Channel Operating Margin (COM) for CDAUI-8 chip-to-chip interfaces

Adam Healey, Avago Technologies
Cathy Liu, Avago Technologies

IEEE P802.3bs 400 GbE Task Force
November 2015

- Table 120D-7 is incomplete (comment #53)
- This presentation contains a proposal to complete the table

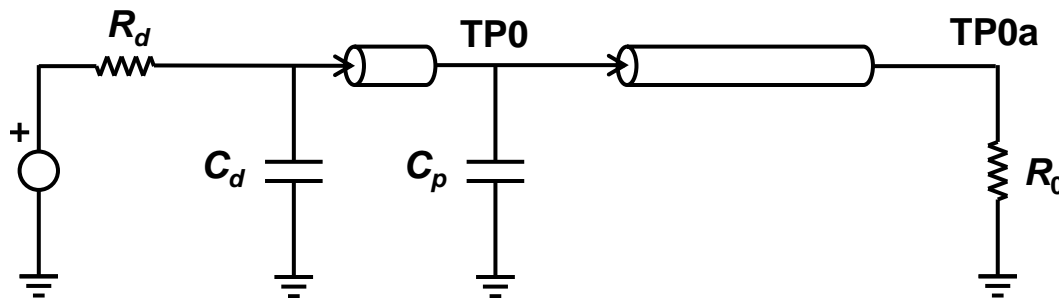
- Define TBD device package and termination parameters
 - Begin with $R_d = 40 \Omega$, $C_d = 280 \text{ fF}$, $C_p = 110 \text{ fF}$
 - In addition, change transmission line Z_c (Table 93A–3) to 90Ω
- Change $b_{\max}(1)$ from 1 to 0.5
 - Larger values appear to be unnecessary
- 2-stage receiver equalizer (replaces Equation 93A–22)

$$H_{ctf}(f) = \left[\frac{10^{g_{DC}/20} + j f / f_z}{1 + j f / f_{p1}} \right] \left[\frac{10^{g_{DC2}/20} + j f / f_{z2}}{1 + j f / f_{p2}} \right]$$

- $f_z = f_{p1} = f_b / 2.5$, $g_{DC} = -15$ to 0 in 1 dB steps
- $f_{z2} = f_{p2} = f_b / 40$, $g_{DC2} = -4$ to 0 in 1 dB steps

Device package and termination parameters

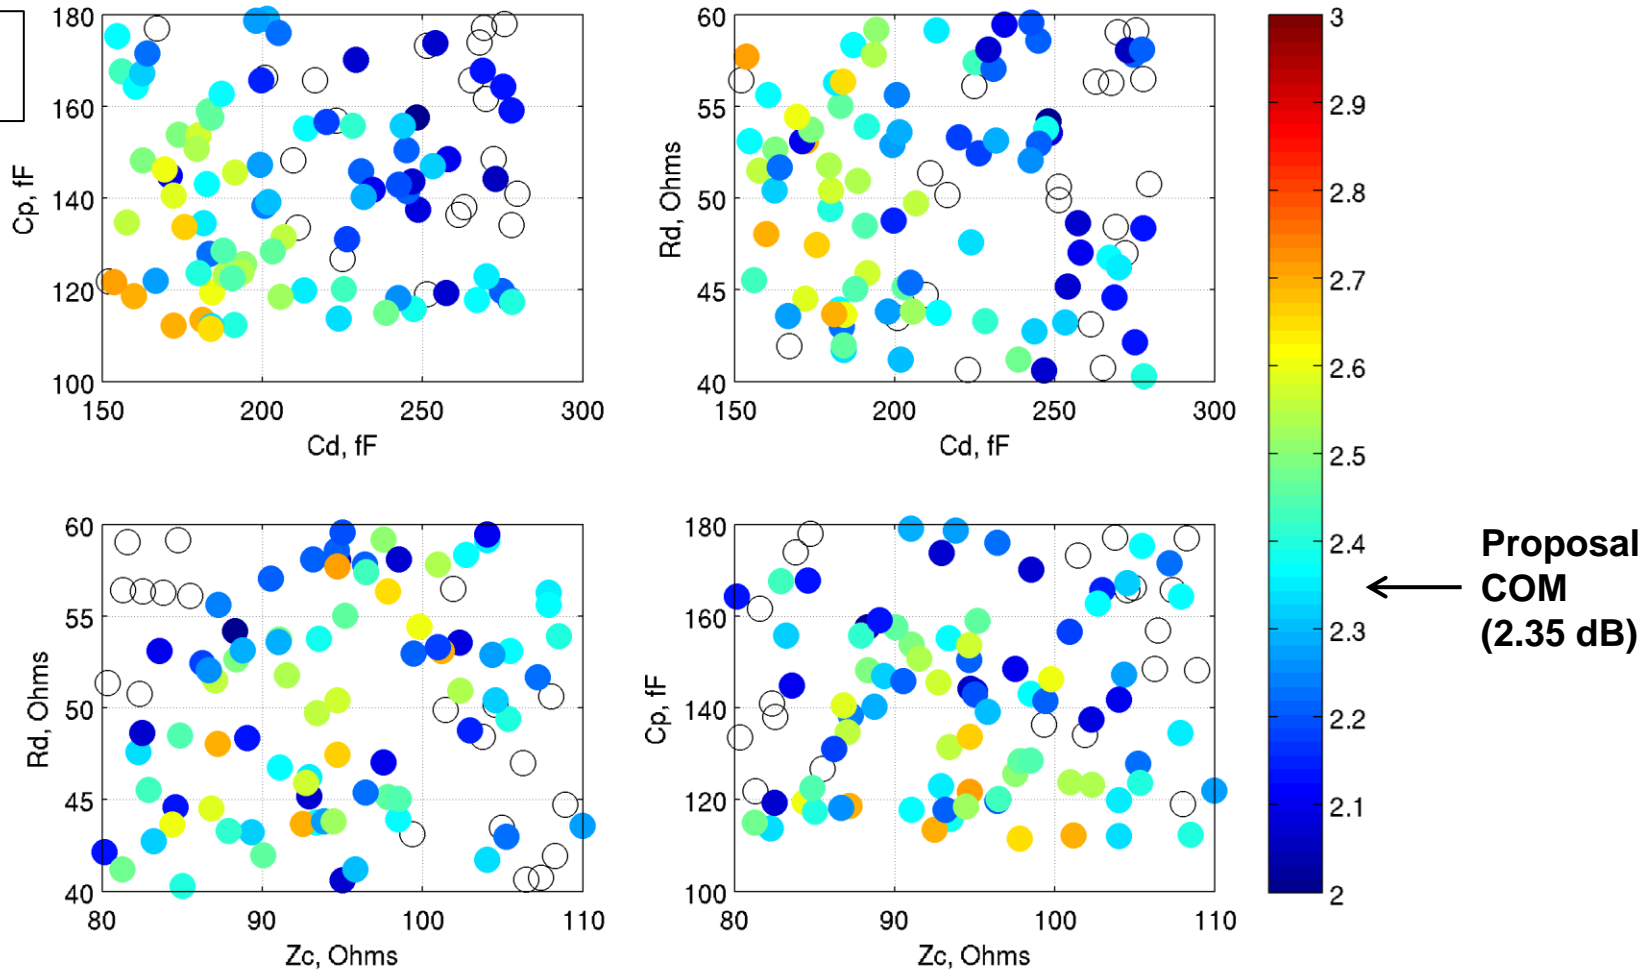
Channel #4
 $z_p = 30$ mm

- 100 trials with uniformly distributed R_d , C_d , C_p , and Z_c values
- Many combinations result in COM similar to or better than proposal
